SAFETY EVALUATION REPORT"CESEC DIGITAL SIMULATION OF A COMBUSTION ENGINEERING
NUCLEAR STEAM SUPPLY SYSTEM" (TAC No.:01142)

II SUMMARY OF CESEC-III AND THE TOPICAL REPORT

FIGURE 3

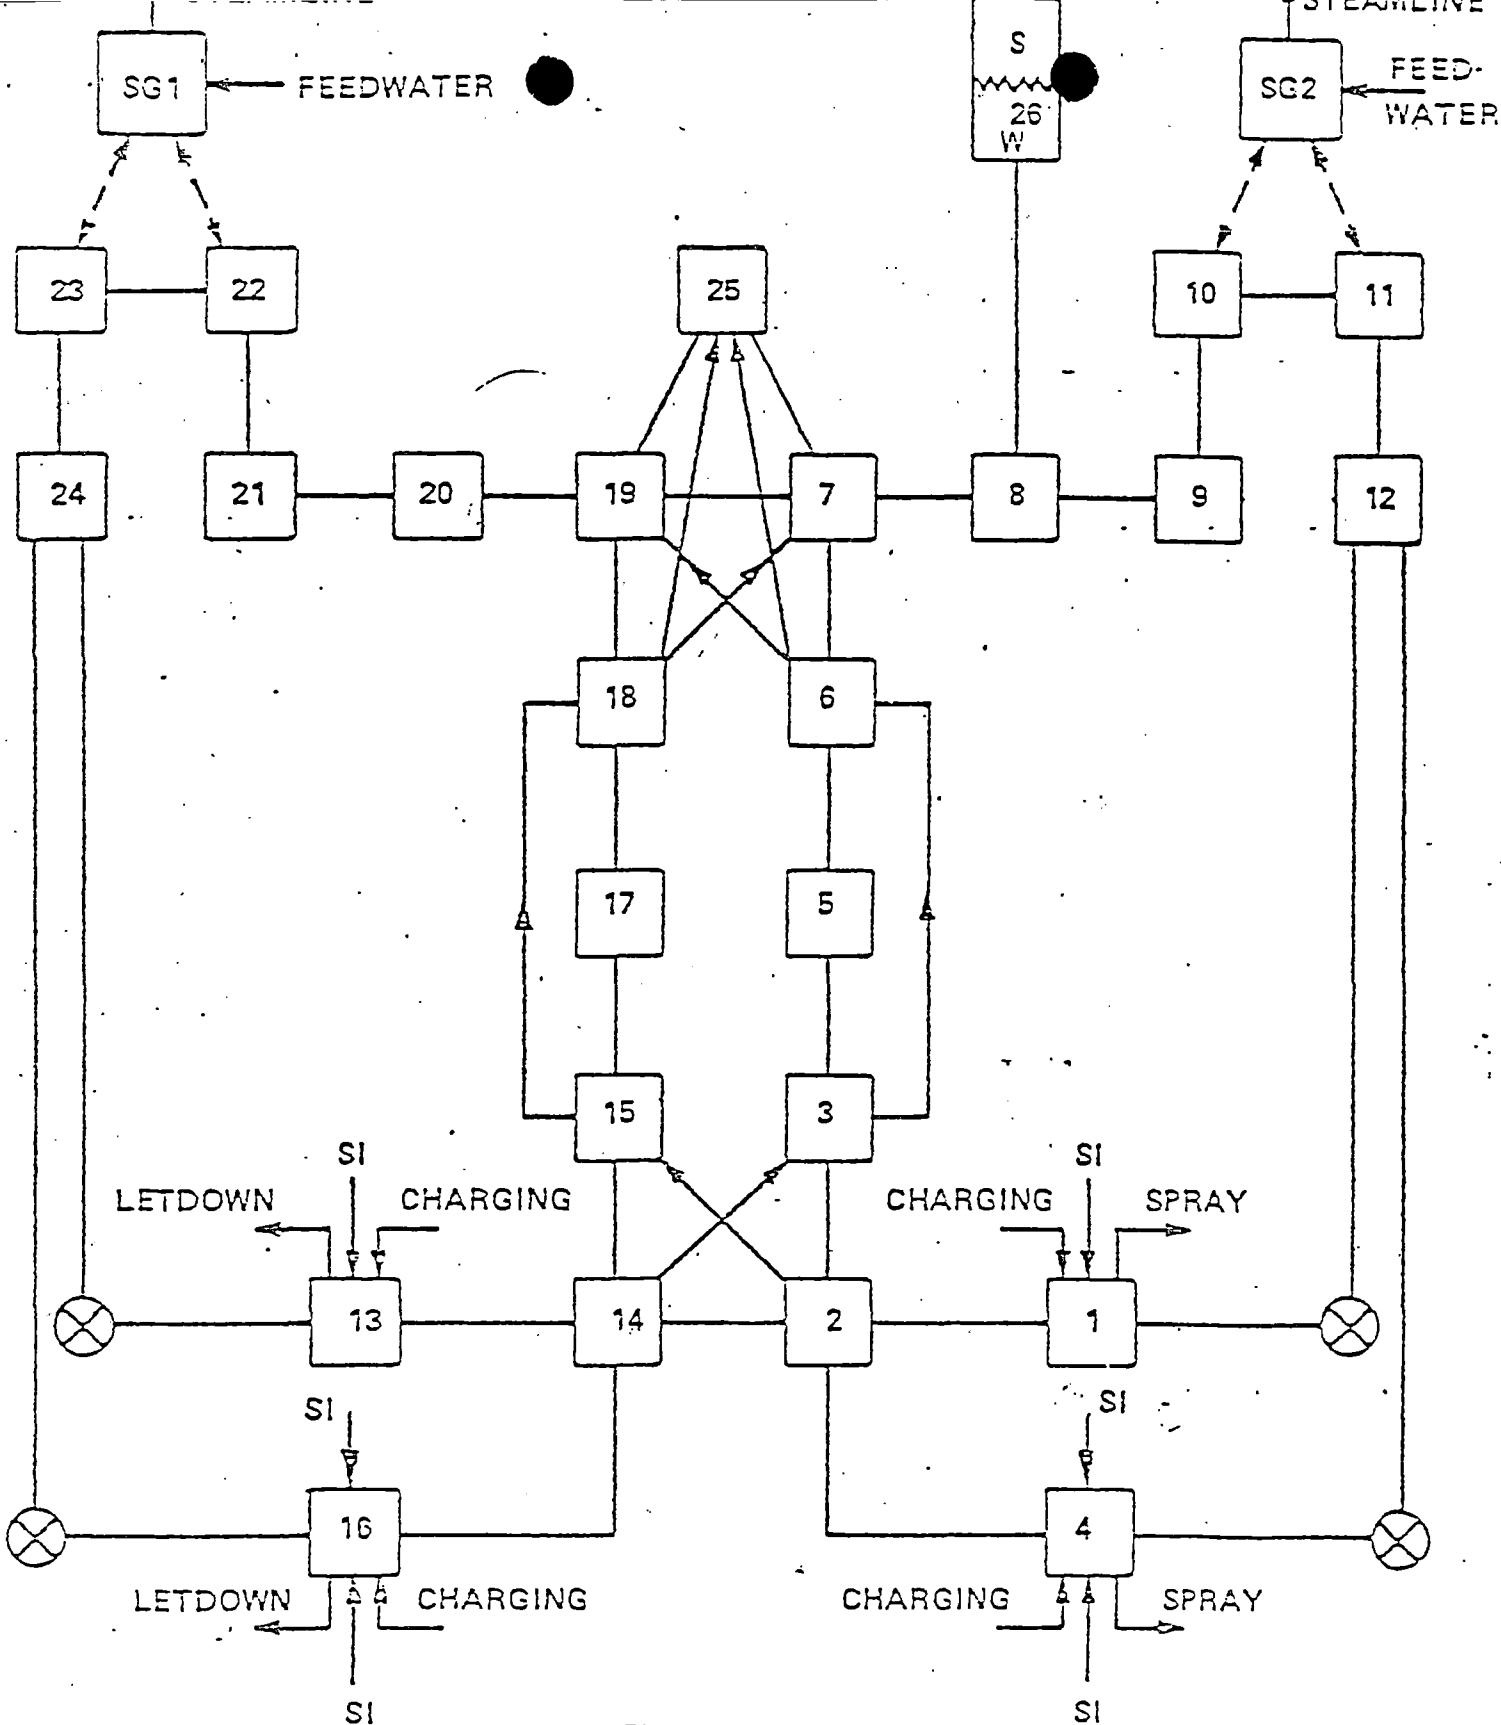
The fixed nodalization developed in CESEC-III is shown in Fig. 3. The reactor vessel is symmetrically split with nodes (volumes) representing the downcomer, inlet plenum, core, outlet plenum, and vessel head. The vessel head is common to both loops. The purpose of the symmetric division is to model asymmetric thermal-hydraulics in the reactor vessel. This is achieved by junctions which transfer a specified fraction of flow between the parallel vessel components. The specified fractions, known as mixing factors, are input to the code. This review does not address the selection of mixing factors. That is being reviewed as part of the methodology of implementation (i.e., steam line break methodology).

The staff finds the applicant's model for neutronics and decay heat acceptable. The modeling of cold-edge temperature and reactivity control is also acceptable.

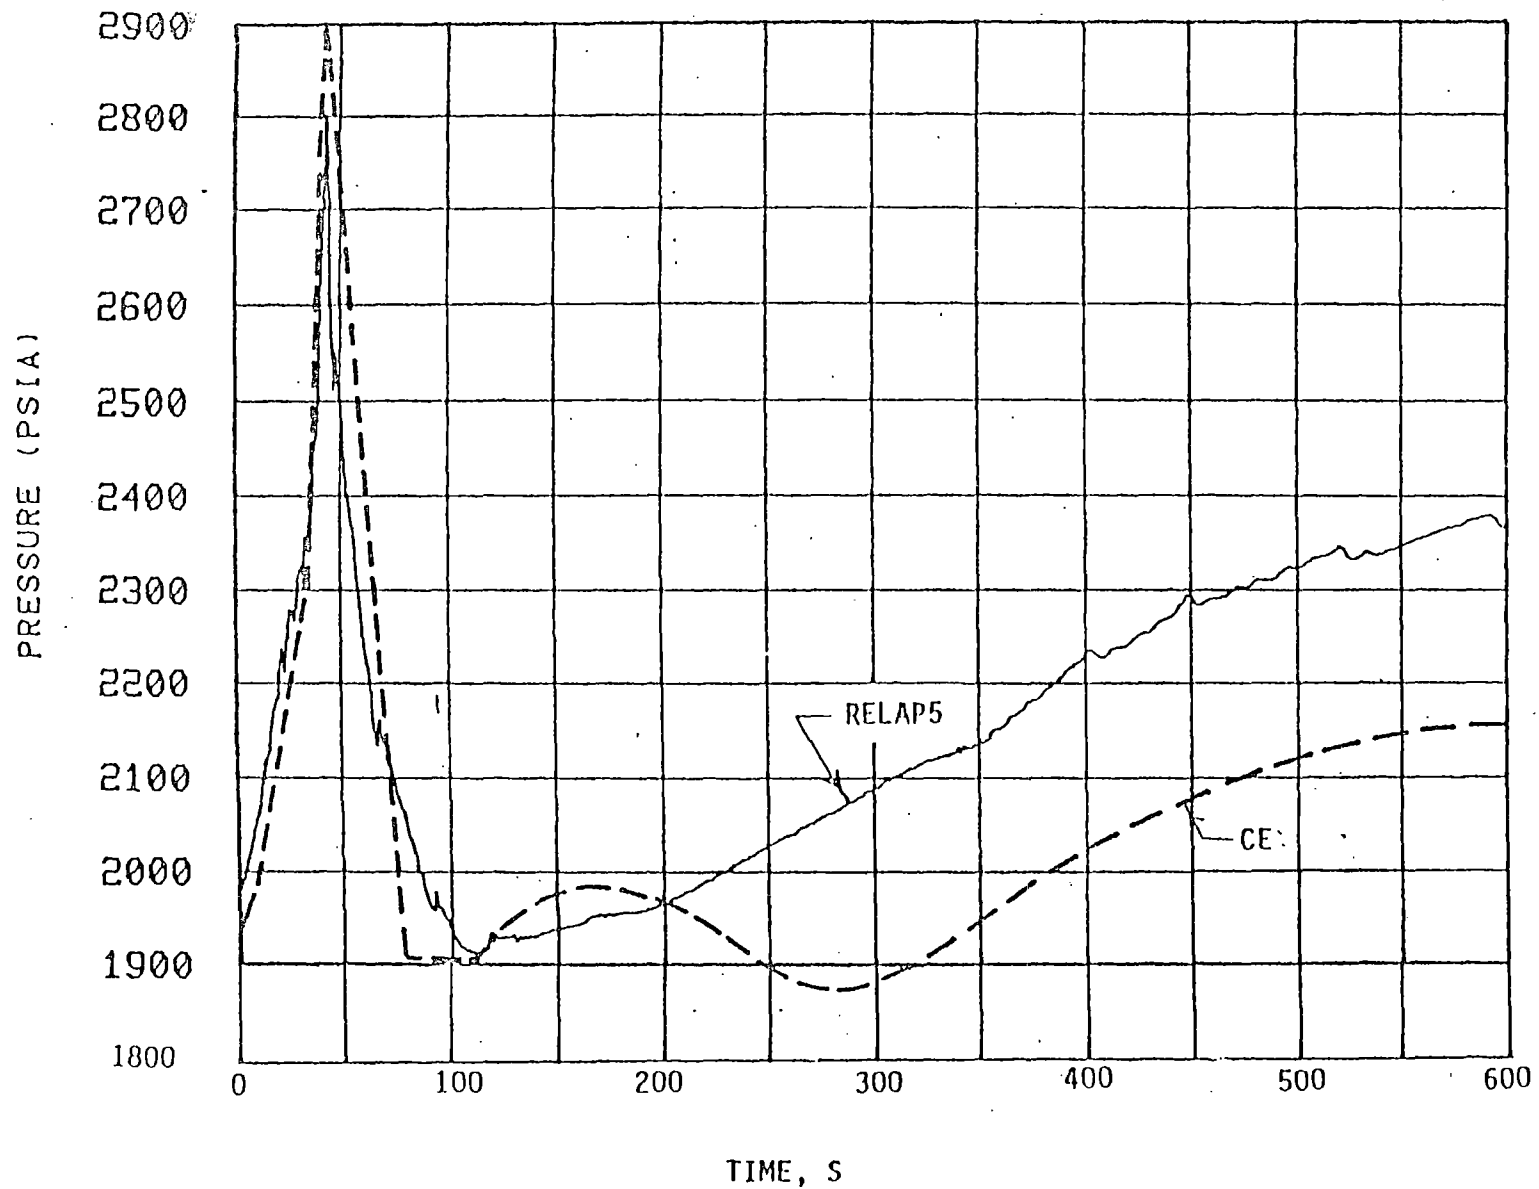
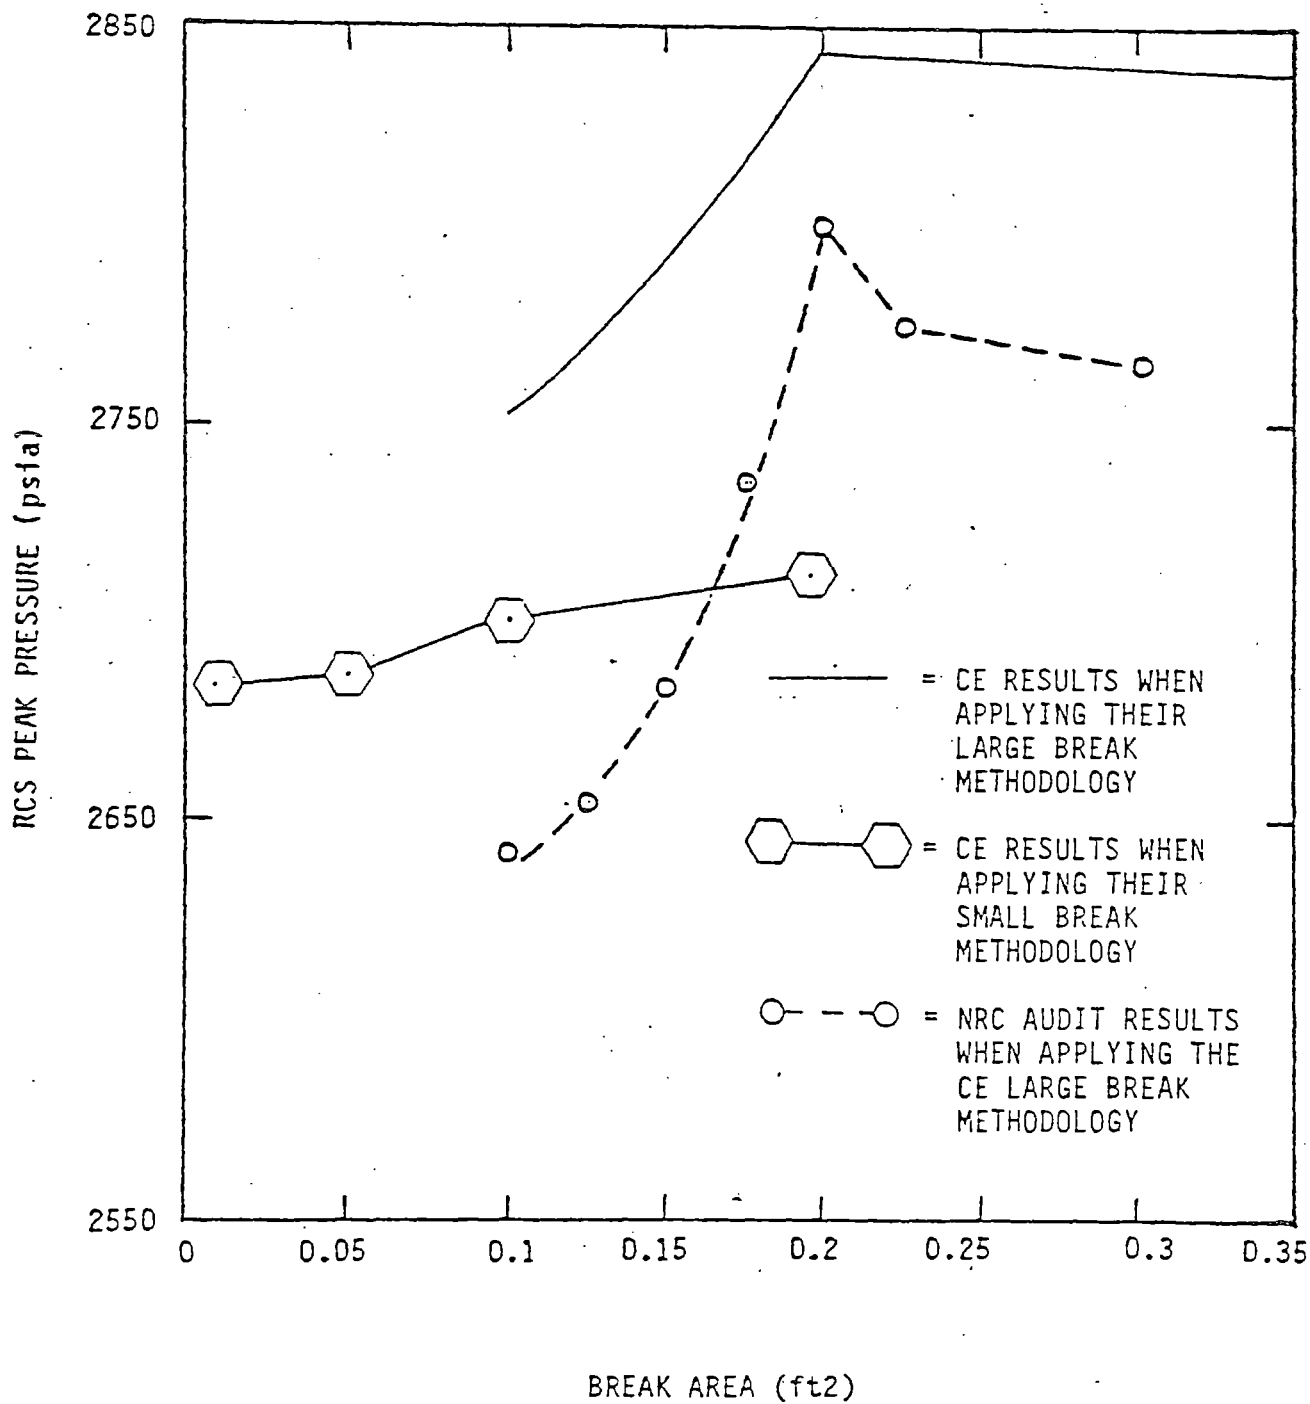
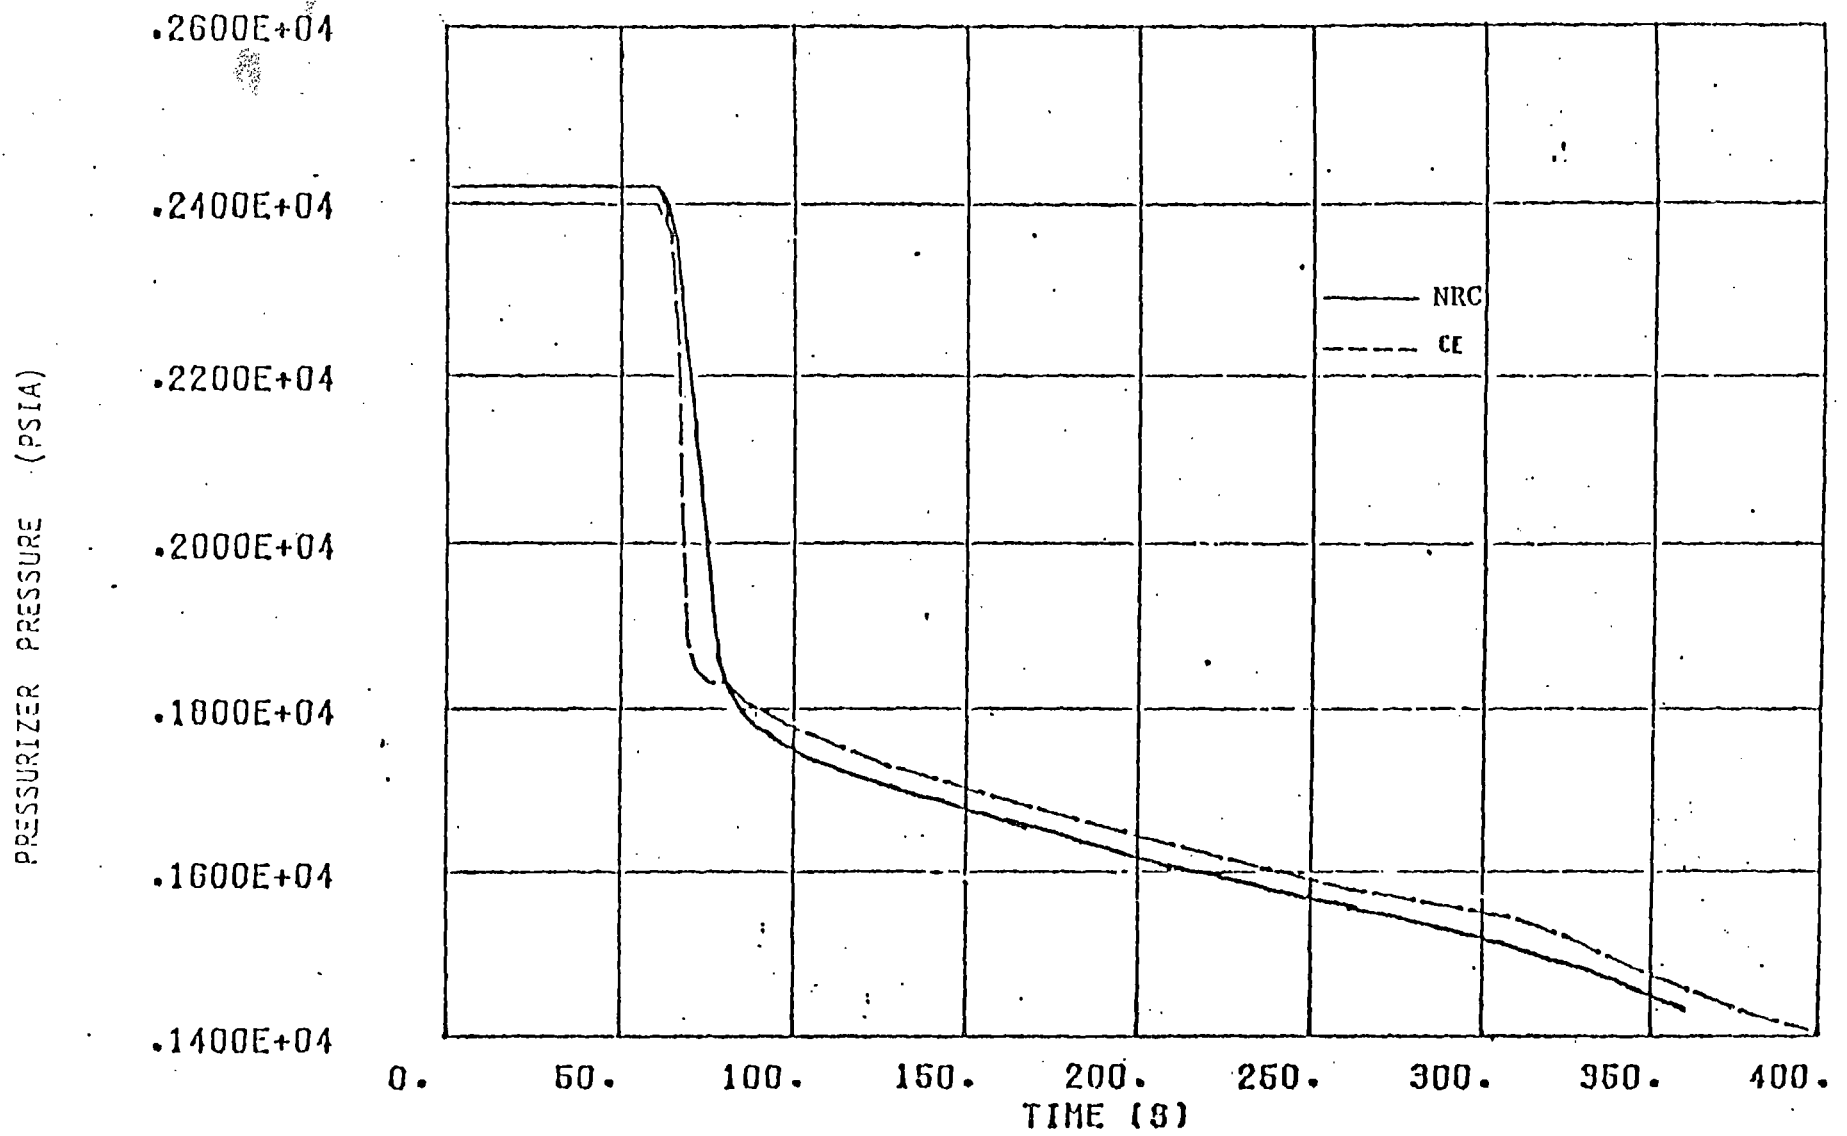
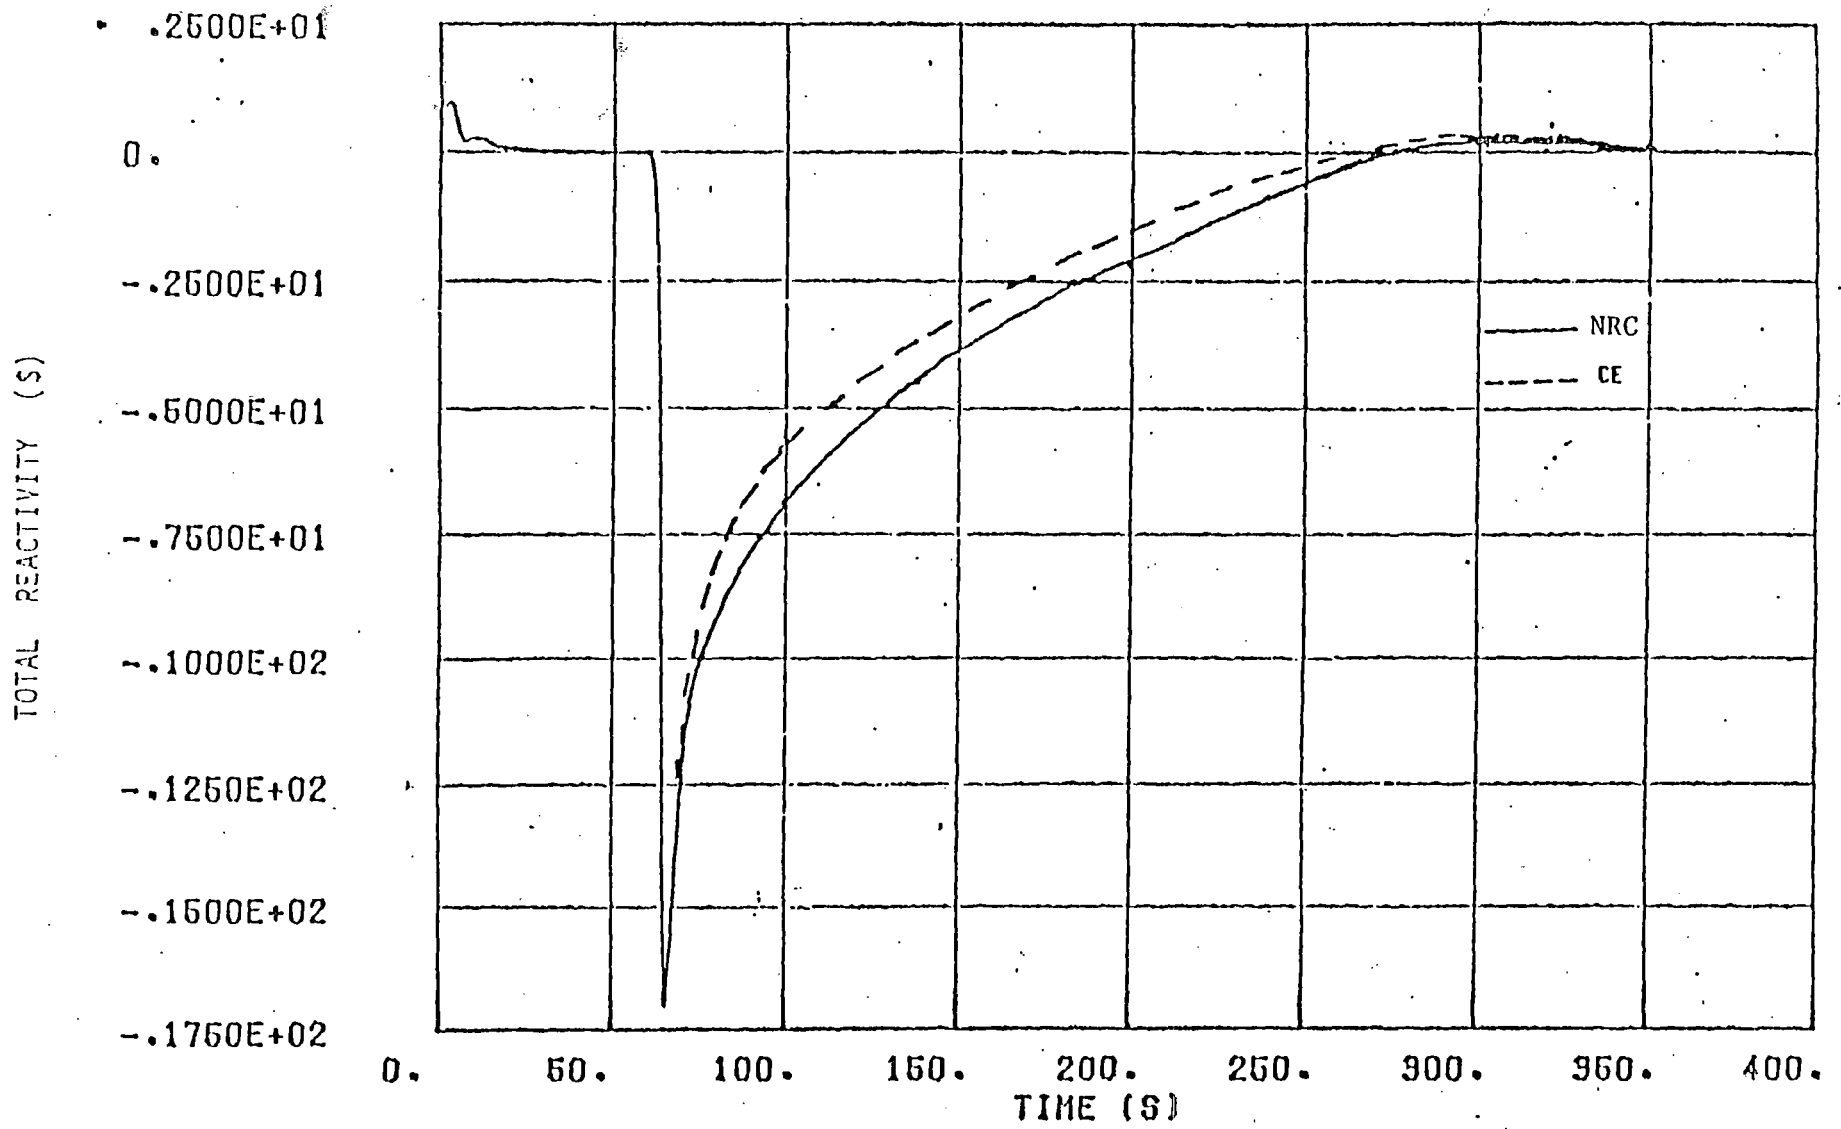
The staff performed audits of CESEC-III using the RELAP5 computer program (an advanced thermal-hydraulic computer program developed by the Office of Nuclear Regulatory Research at NRC). These audit calculations were of the System 80 steam and feedwater line break events. Details of these audits are documented in Appendices H and G of Revision 1 to the System 80 SER. Figures 1, 2, 3 and 4 illustrate the good agreement between the two codes and the conservative trend predicted by CESEC-III. The audit calculation attempted to model the events with similar boundary and initial conditions as applied by CE. The feedwater line break audit confirmed the acceptability of CESEC-III to model severe pressurization events and the steam line break audit confirmed the acceptability of CESEC-III to model severe depressurization events.

The conclusions of these audits confirmed the acceptability of CESEC-III to calculate the thermal-hydraulic responses of the reactor coolant system with the boundary conditions employed. To predict conservative consequences, the applicant applies conservative constraints on the boundary conditions. The staff's audits confirmed the code's acceptability when applying these constraints.
